Addendum / Addenda

Project Description / Description de projet M02M10 Re-Roof Project		
Solicitation No./N° de sollicitation 16-22069	Project No./N° de projet 5230	W.O. No./N° d'ordre de travail A1-006900-03-01
Departmental Representative / représentant ministériel Kirk Williams		Date September 6, 2016
Notice: This addendum shall form part of the tender documents and all conditions shall apply and be read in conjunction with the original plans and specifications.		Nota: Cet addenda fait partie intégrale des dossiers d'appel; toutes les conditions énoncées doivent être lues et appliquées en conjonction avec les plans et les devis originaux.

project: **ROOF REPLACEMENT BUILDING M-02, ROOF AREAS 1, 2, 4 + 5 BUILDING M-10, ROOF AREAS 1, 2 + 5 1200 MONTREAL ROAD, OTTAWA NATIONAL RESEARCH COUNCIL**

drawing: **ROOF AREA 1, PLAN AND DETAILS BUILDING M-02**

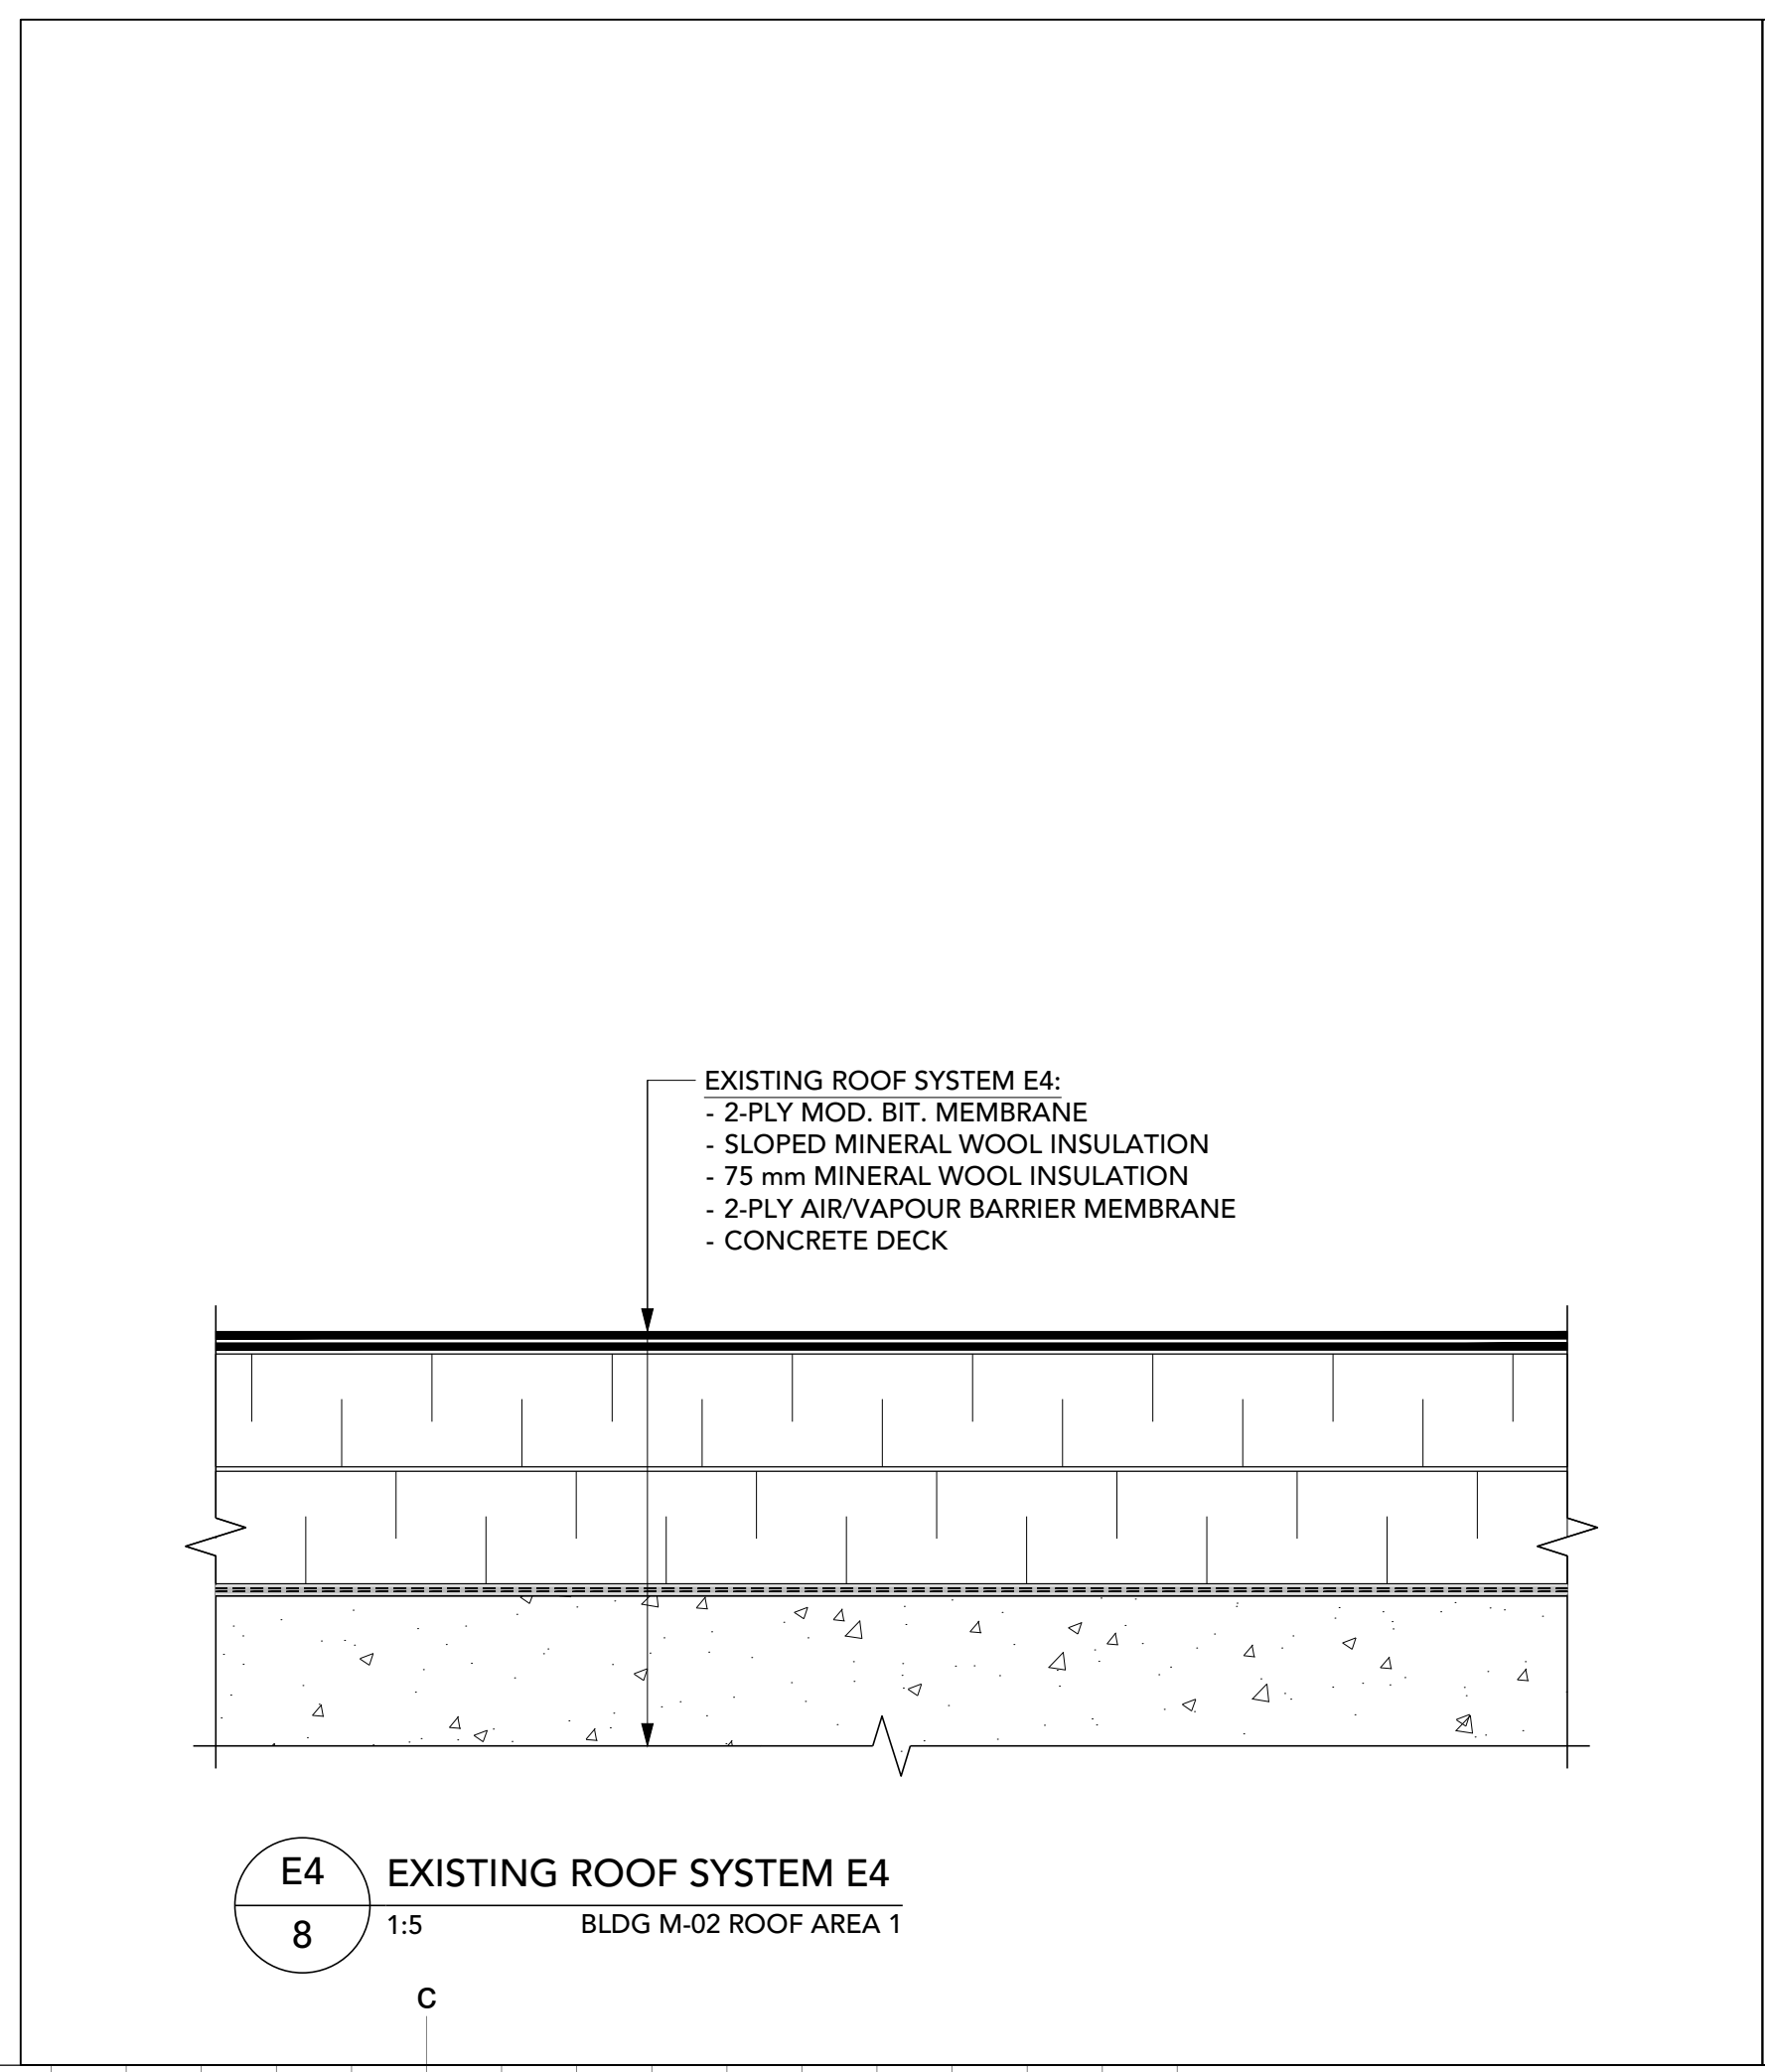
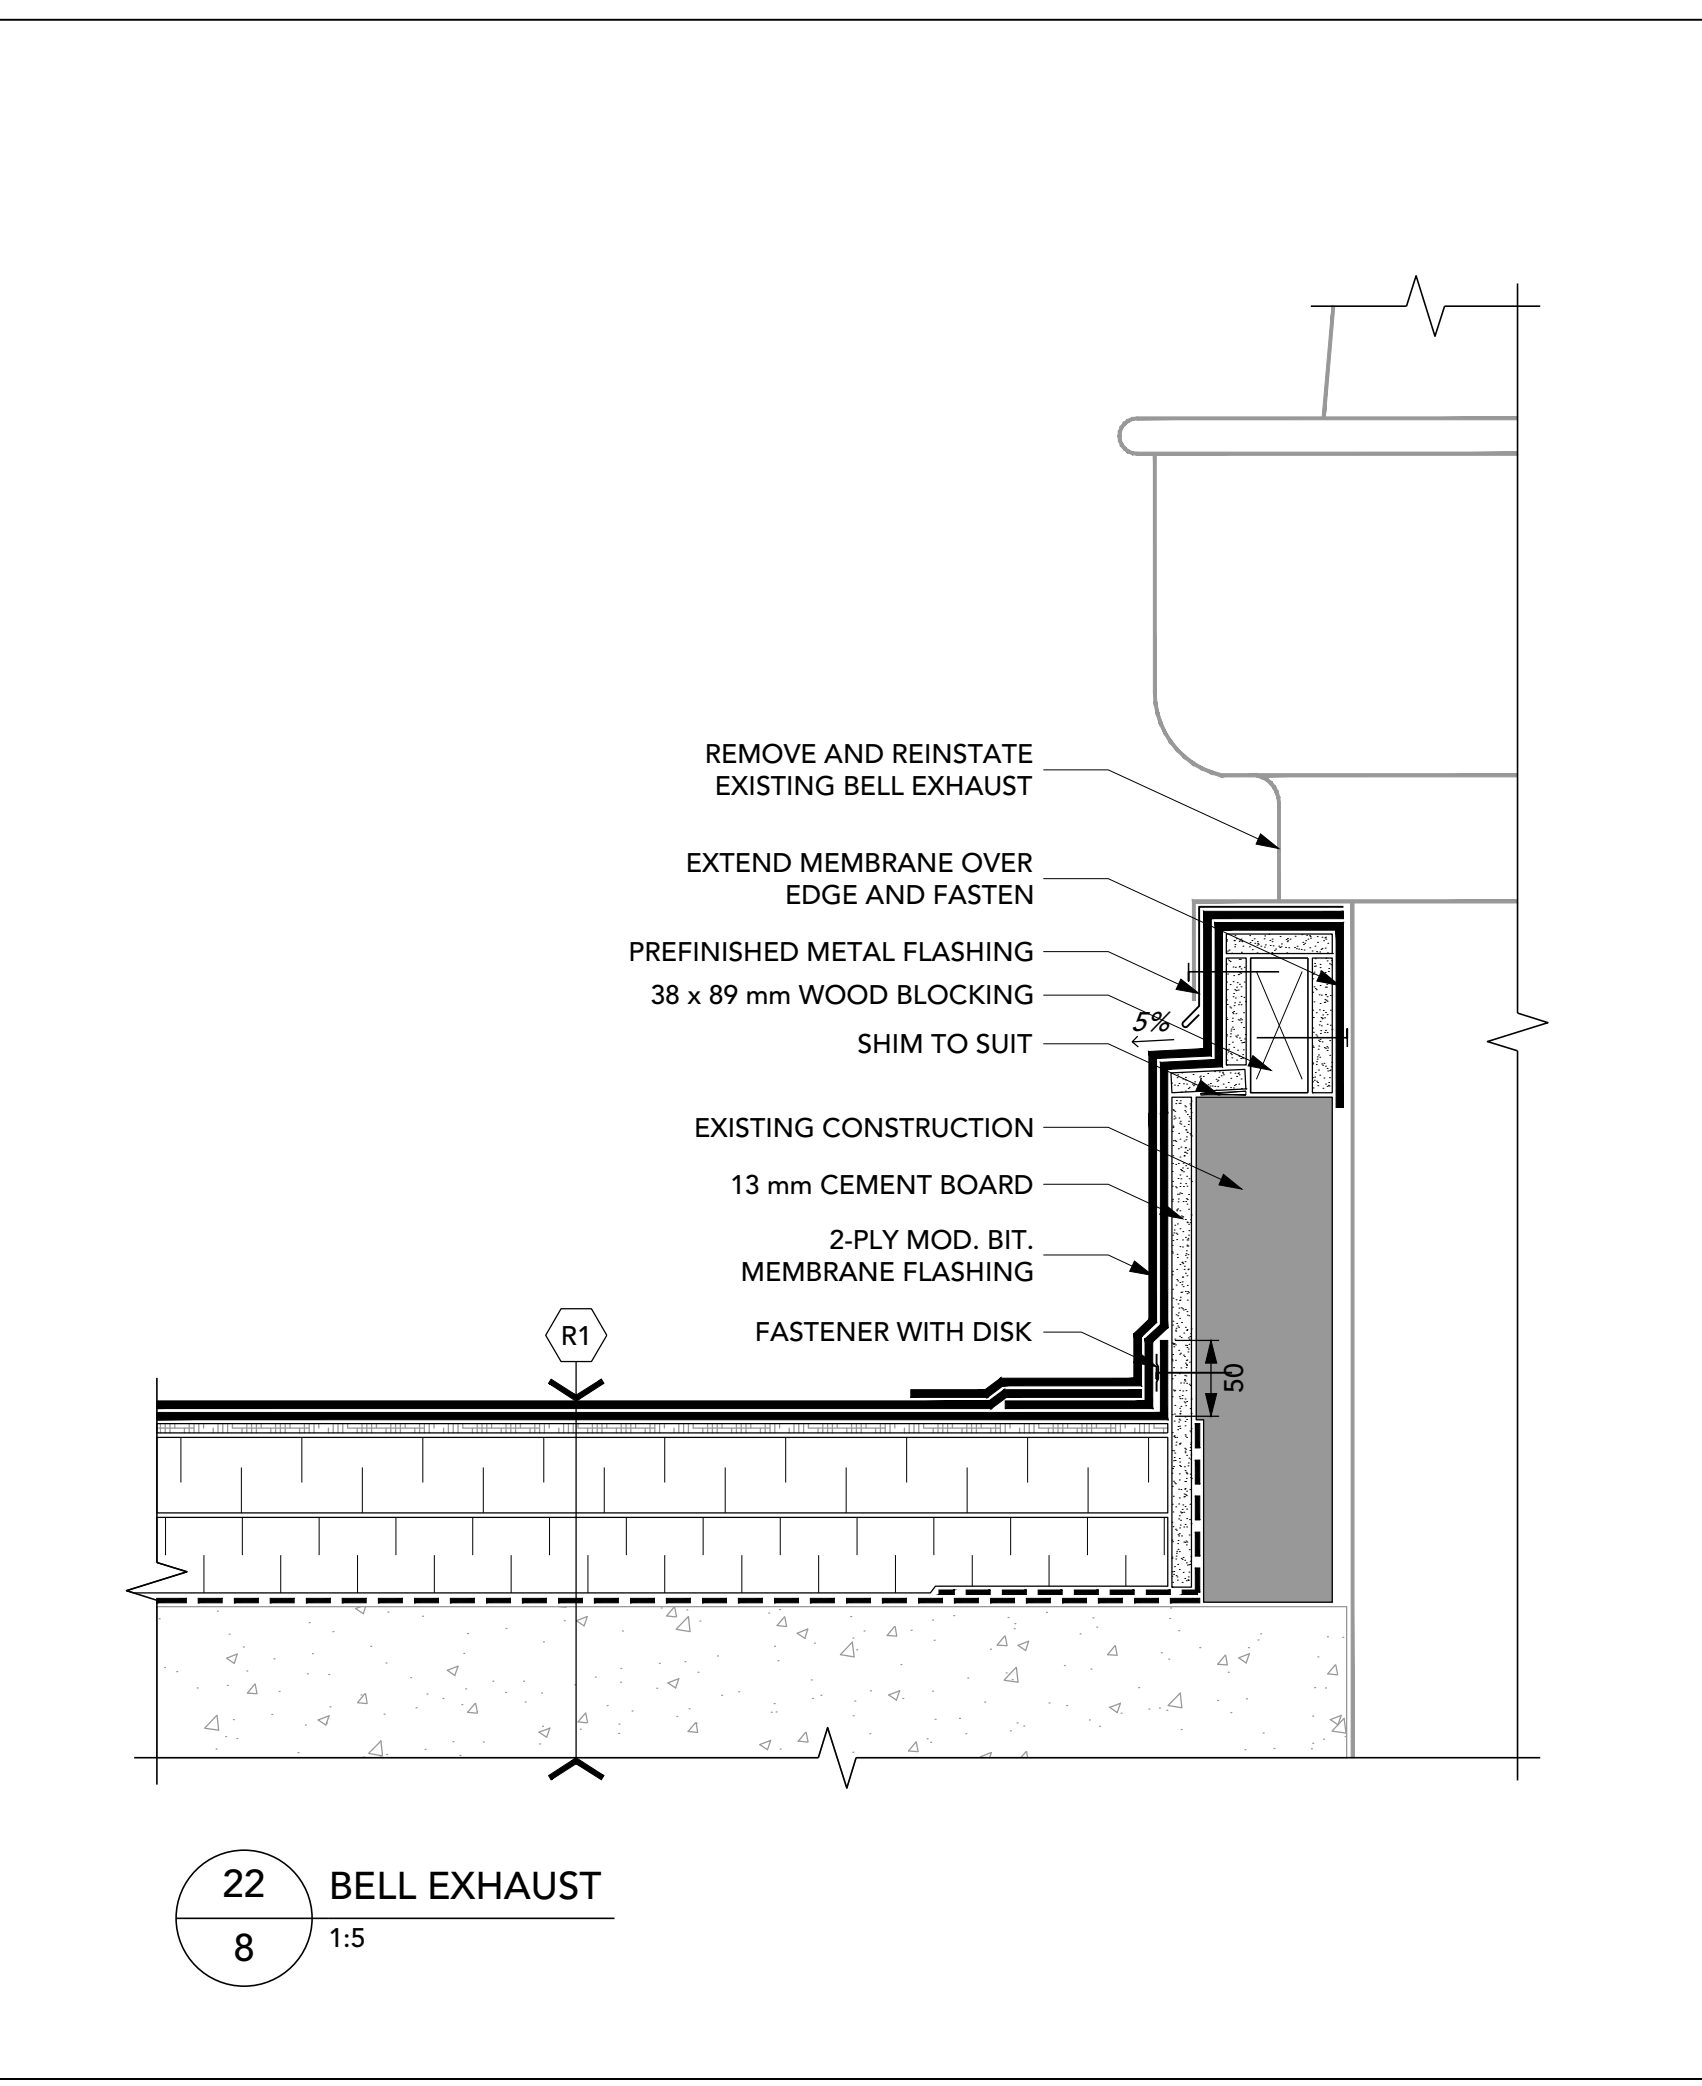
3. Add north wing of Building M2 to contract as indicated on roof plan drawing, attached. Construction detailing and specifications are provided in the original documents.
4. The Mandatory Site Visit Attendance Sheets are attached.
